## **FAYETTE COUNTY PRISON**

#### **ADDENDUM No. 7**

Issue Date: April 5, 2021

**BID DOCUMENTS**  
LANDSCAPING PLAN  
C109R1 of C120  
SD-C401

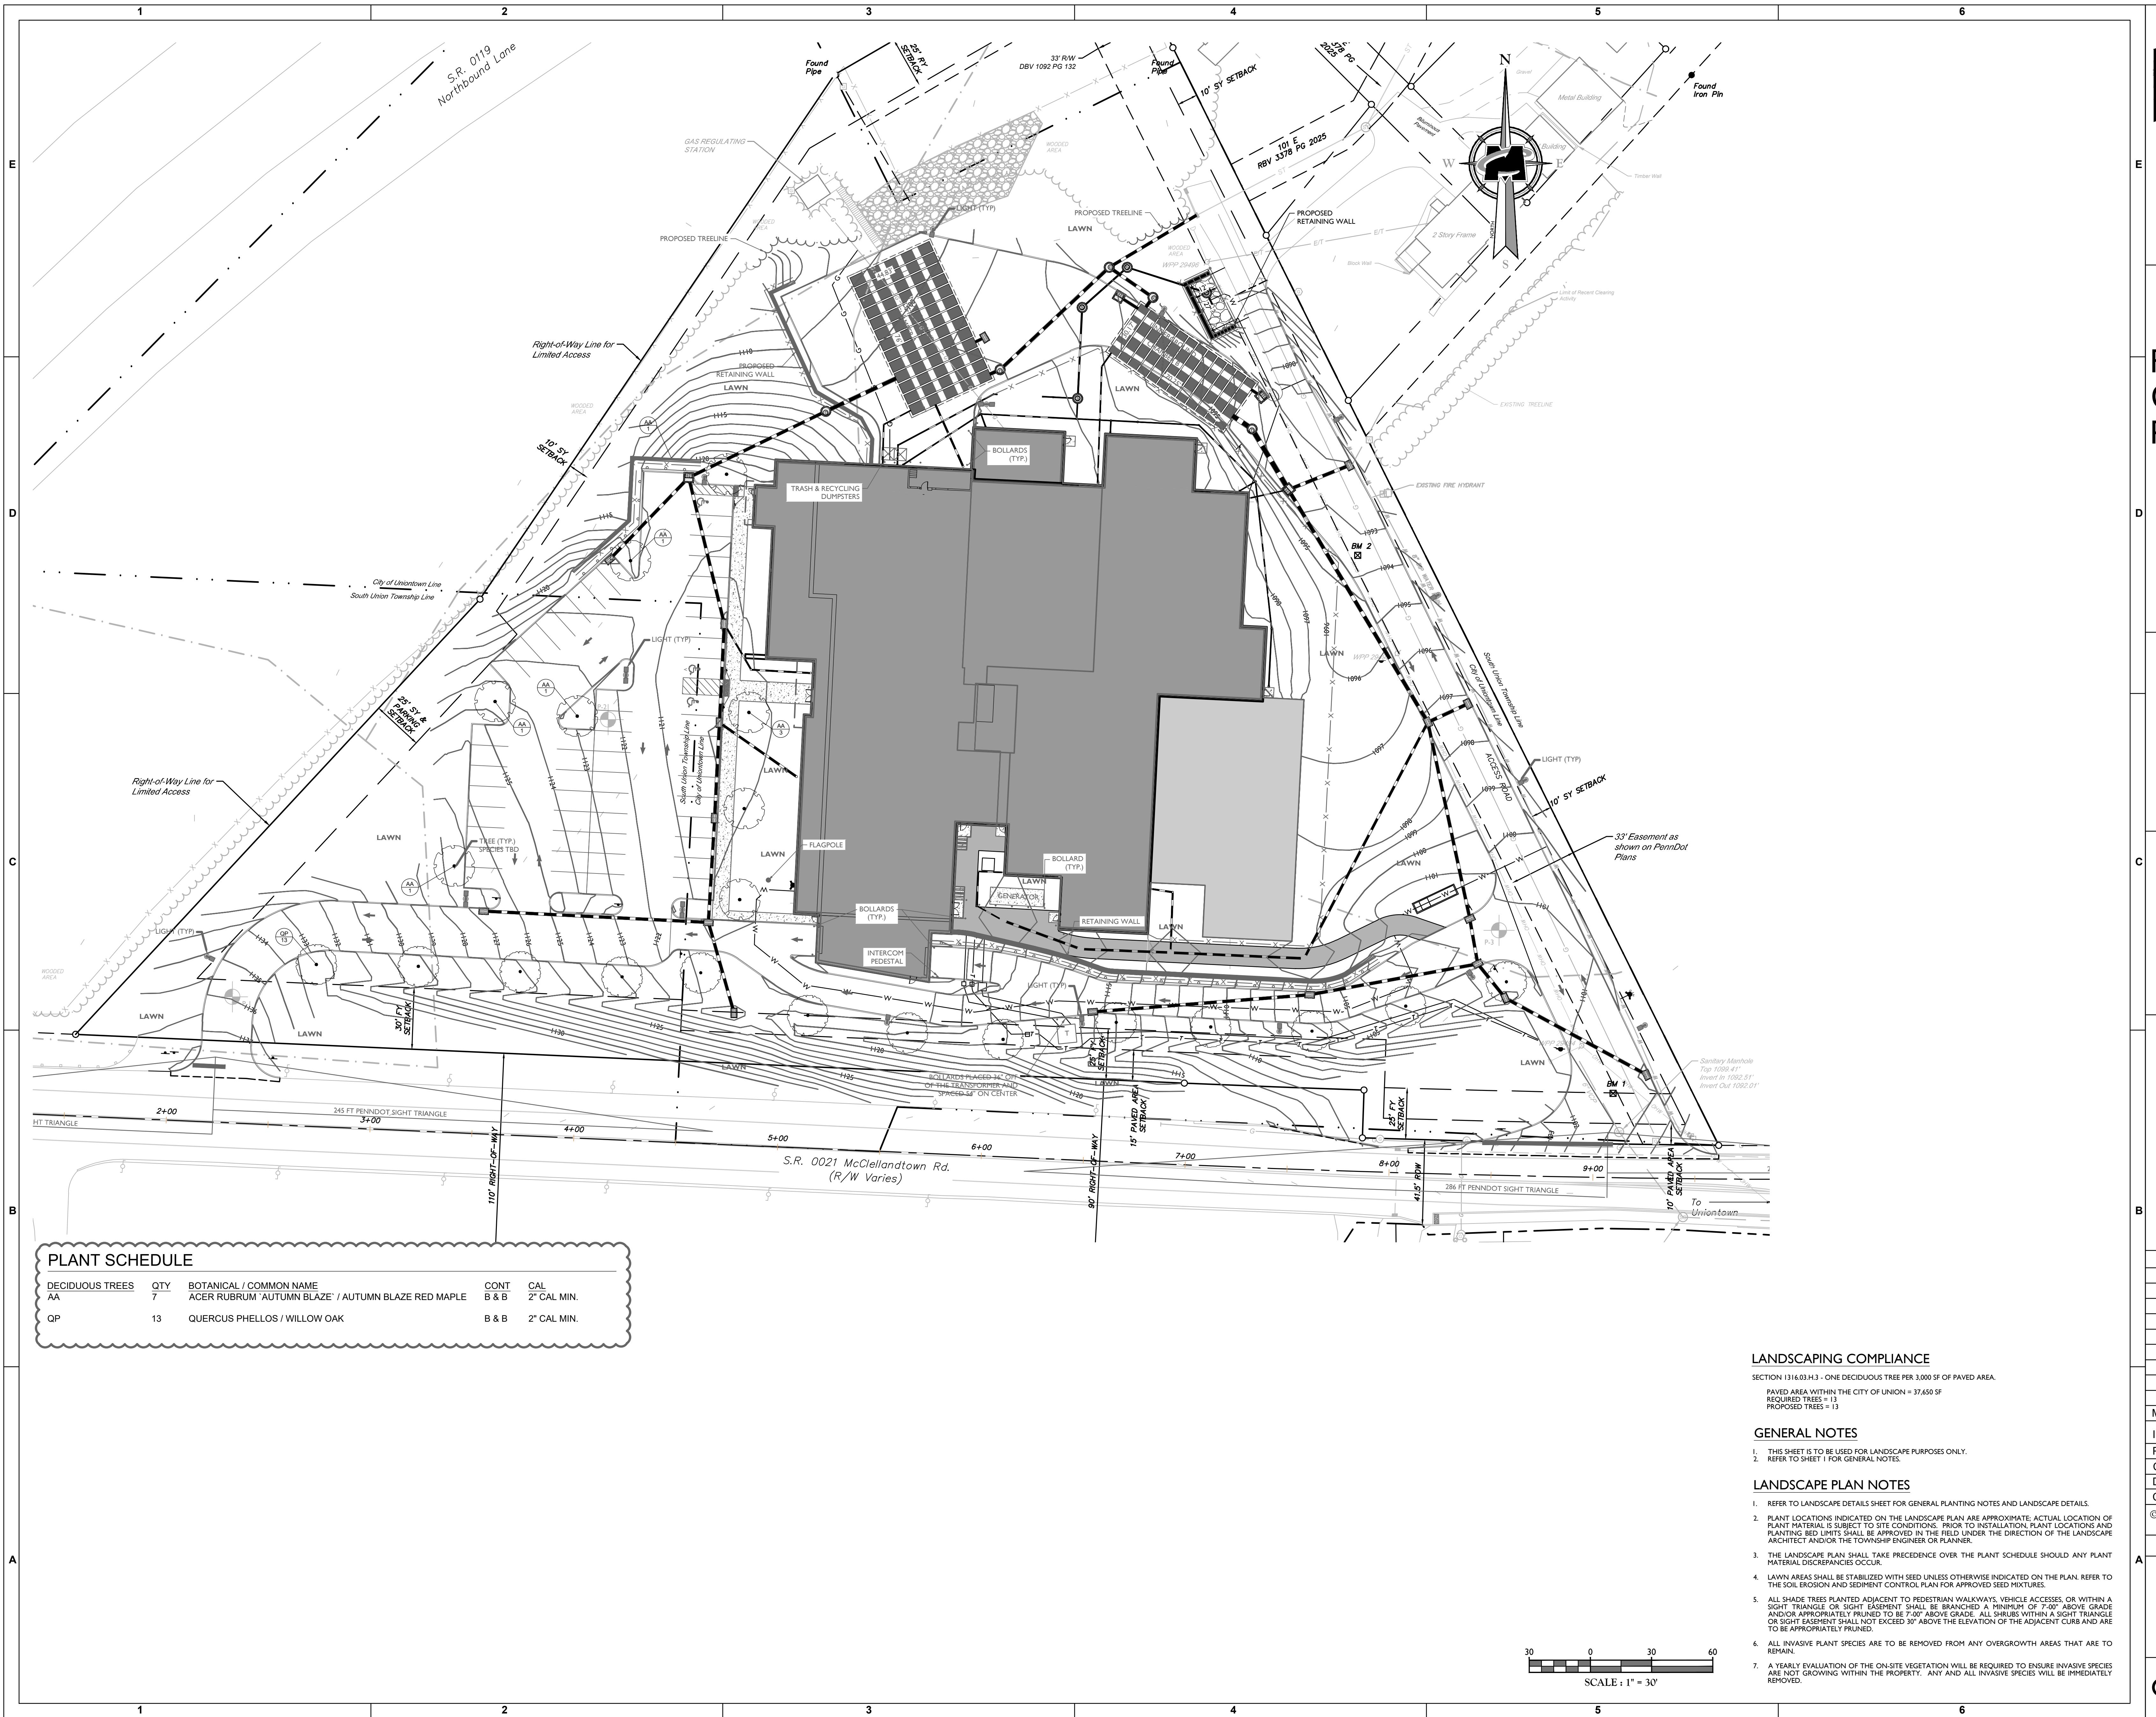
**C109 LANDSCAPING PLAN**

1. DELETE Drawing C109 in its entirety and INSERT Drawing SD-C401, C109 RI – Landscaping Plan.
